Device **TC26x**
Marking/Step **ES-BC, BC**
Package **see Data Sheet**

No. 165/17

This Errata Sheet describes the deviations from the current user documentation.

Figure 3 Message RAM Configurations

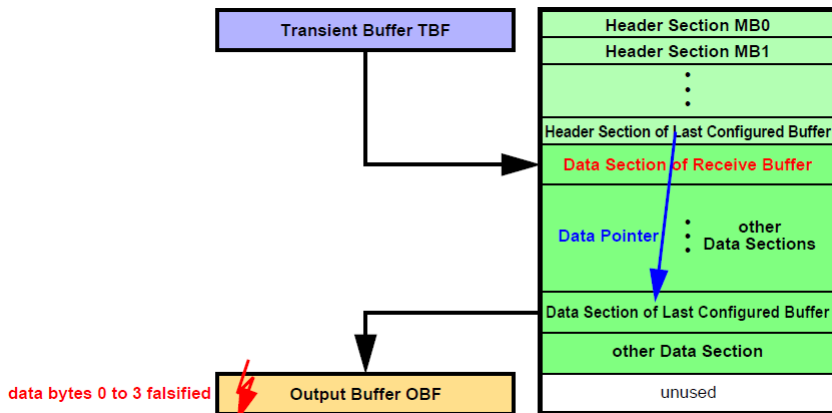
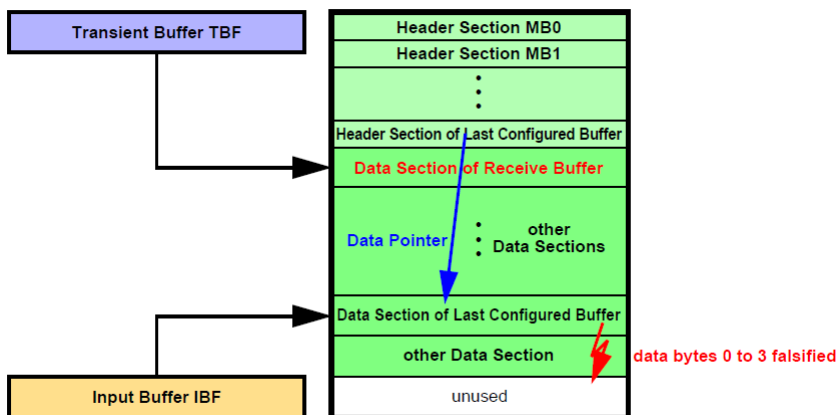
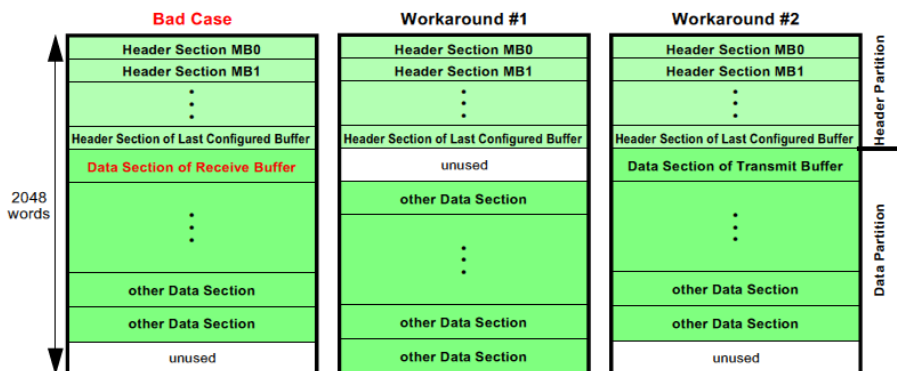
When the message buffer has its payload configured to maximum length (PLC = 127), the OBF word on address 00h (payload data bytes 0 to 3) is overwritten with unexpected data at the end of the transfer.

After the Data Section of the selected message buffer in the Message RAM has been written, one additional write access overwrites the following word in the Message RAM which might be the first word of the next Data Section.

- a) When a message is transferred from the Last Configured Buffer in the Message RAM to the OBF and **PLC = 127** it may happen, that at the end of the transfer the OBF word on address 00h (payload data bytes 0 to 3) is overwritten with unexpected data (see [Figure 1](#)).
- b) When a message is transferred from IBF to the Last Configured Buffer in the Message RAM, it may happen, that at the end of the transfer of the Data Section one additional write access overwrites the following word, which may be the first word of another message's Data Section in the Message RAM (see [Figure 2](#)).

2) Ensure that the Data Section directly following the Header Partition is assigned to a transmit buffer.

Figure 4 Example sequence showing how registers ETRRx may be filled with “Error Free” addresses

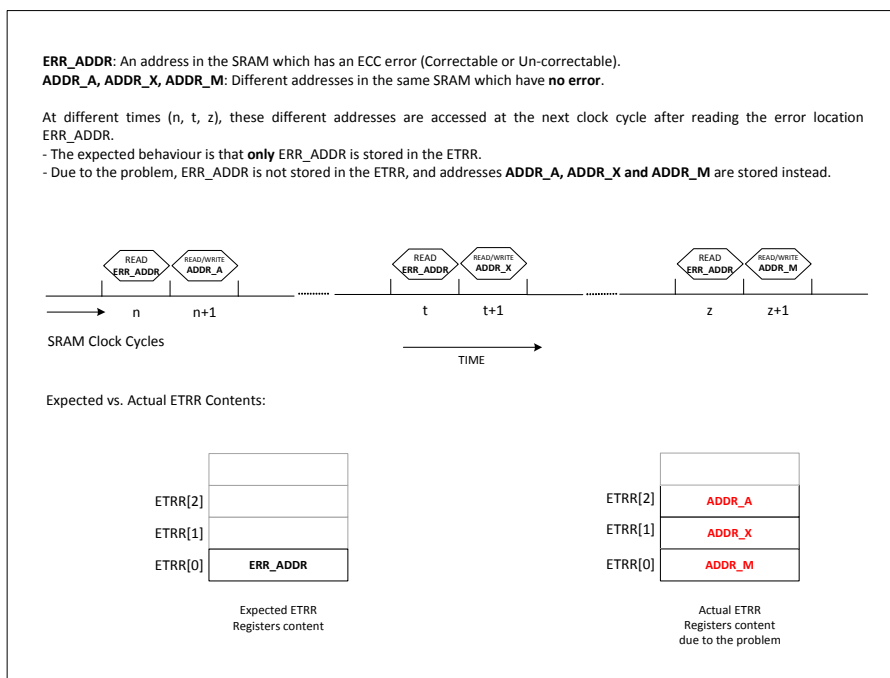
When such a consecutive access sequence (read from ERR_ADDR followed by read/write of different address(es)) happens multiple times, registers ETRRx are filled with addresses that have actually no error – and the SRAM address which actually has an error is not stored indeed. **Figure 4** shows such an example scenario.

The consequence of the scenario explained in **Figure 4** is that a single error in the SRAM – example just one correctable error at a location ERR_ADDR – can

1. For the affected SRAMs, the addresses stored in ETRRx may not be reliable. Depending on the access sequences, ETRRx may contain the correct error address, or in the worst case all ETRRx entries may contain fault-free addresses.
2. Depending on the access sequences, an ETRR overflow might be triggered with one real error (e.g. correctable error) in the SRAM – consequence of the example shown in [Figure 4](#).

Figure 5 Recommended Software Handling - Flowchart

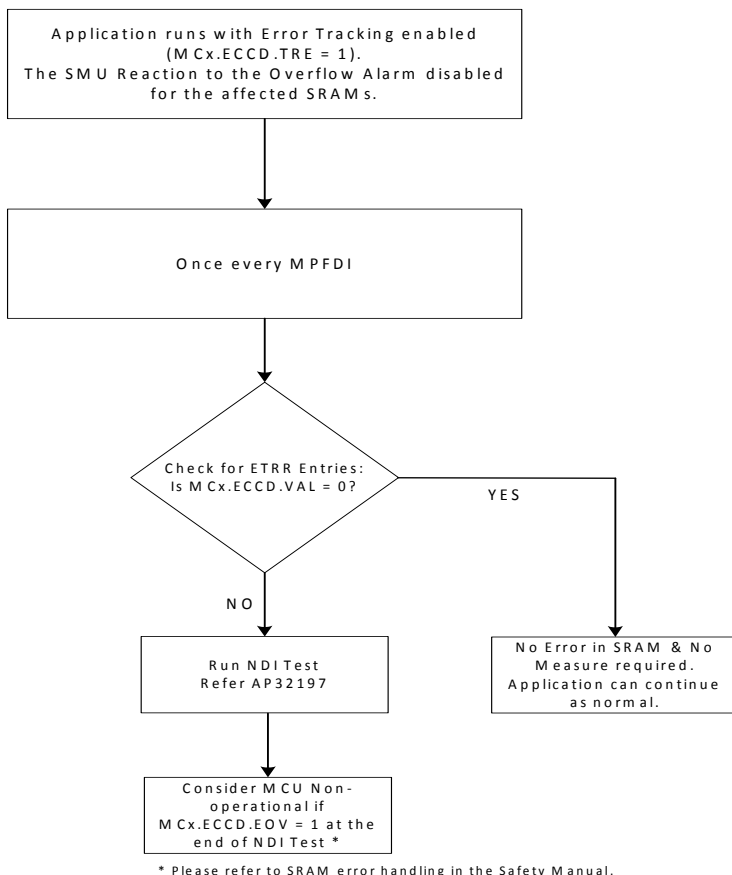
A flowchart of the recommended software handling is shown in [Figure 5](#).

If there is at least one valid ETRR entry (i.e. $MCx.ECCD.VAL \neq 0$) then the software shall run a Non-Destructive-Inversion (NDI) Test on the affected SRAM. Please refer to application note AP32197 (AURIX™ Memory tests using the MTU) for an example regarding running this test.

At the end of this test, if an ETRR overflow is detected ($MCx.ECCD.EOV = 1_B$) then the MCU shall be considered non-operational. Refer to section on Correctable SRAM Error handling in the Safety Manual.

Figure 15 SENT Tolerance of this Design Step

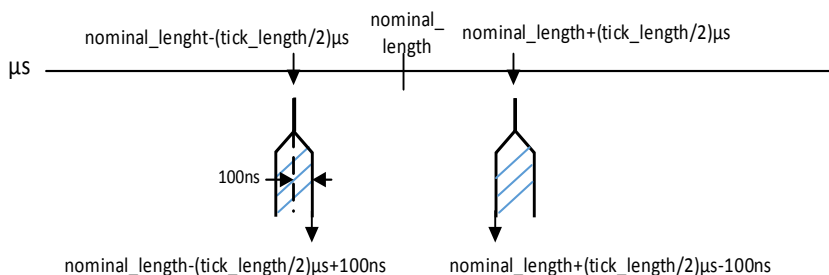
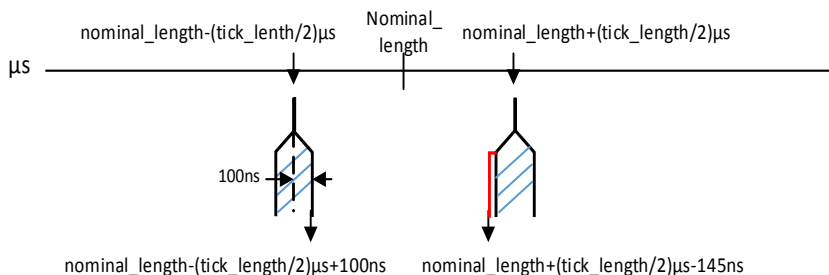
In this design step the range is delimited as follows:

- The lower border is $\text{nominal_value} - (\text{tick_length}/2) \mu\text{s} + 100 \text{ ns}$
- The upper border is $\text{nominal_value} + (\text{tick_length}/2) \mu\text{s} - 145 \text{ ns}$.

Figure 16 Short Serial Message, Serial Data Encoding over 16 messages

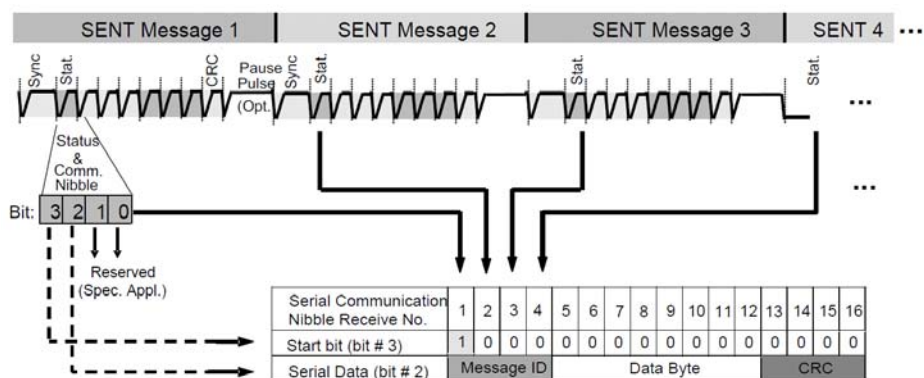
In Figure “Short Serial Message, Serial Data Encoding over 16 messages” of the SENT chapter, the arrows originating from bits 2 and 3 of the Status & Comm Nibble are routed incorrectly and must be swapped.

Figure 16 shows a corrected version of this figure.
